UPPER SOUTH CREEK ADVANCED WATER RECYCLING CENTRE

Operational Noise Review

This letter confirms our review and verification of Revision 5 of the Operational Noise Review (ONR) for the Sydney Water Upper South Creek Project (USCP), in fulfilment of our responsibilities under Condition of Approval E56 of planning approval SSI 8609189.

Figure 6-1: Noise emission from a single brine water control valve, sound pressure level dB(A) at 1 metre

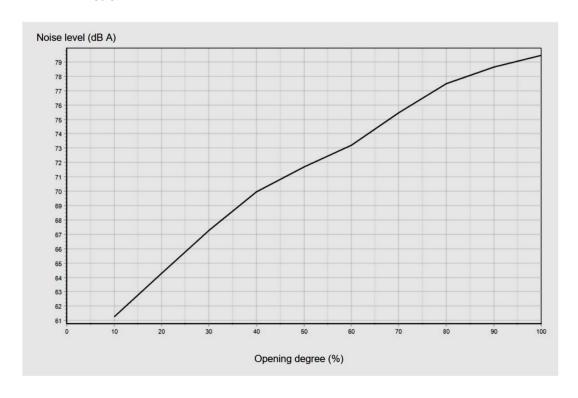
20	Section 6.2.1	How is the value of 91dBA obtained from Figure 6-1 for the brine water control valve operating at a flow rate of 100L/s, 82% open?	0	This information was provided by the design joint venture and was,in turn, supplied by the equipment supplier. Confirmation (RTA)	Brine water control valve station figure reference needs changing from 6-5 to 6-4.	31-Mar-25	Updated	MT	Closed.		02-Jun-25
21	Section 6.2.1	How is the value of 100dBA obtained from Figure 6-2 for the brine water control valve operating at a flow rate of 100L/s, 82% open?	0	This information was provided by the design joint venture and was,in turn, supplied by the equipment supplier. Confirmation (RTA)		31-Mar-25					
22	Figure 6-5	Please fix up the legend so that the explanation for the blue dot is not obscured.	0	Updated figure AM (RTA)		31-Mar-25					
23	Table 7-1	Why is the CONCAWE algorithm being used? Why not use ISO 9613-2:1996 implementing quality standard ISO 17534-1:2015 as is done in the Gatewave model?	0	CONCAWE was used for the operational noise model for consistenct with the EIS and because it allows for finer control over the assumed meteorological conditions, giving greater certainty of meeting the NPfI's requirement to consider either 'standard'or 'noise enhancing' meteorological conditions. In RTA's experience, ISO9613-2 is a general-purpose algorithm which has proven to be useful for presenting realistic worst-case construction noise predictions which is why it has been used for construction-phase noise predictions via Gatewave.		31-Mar-25
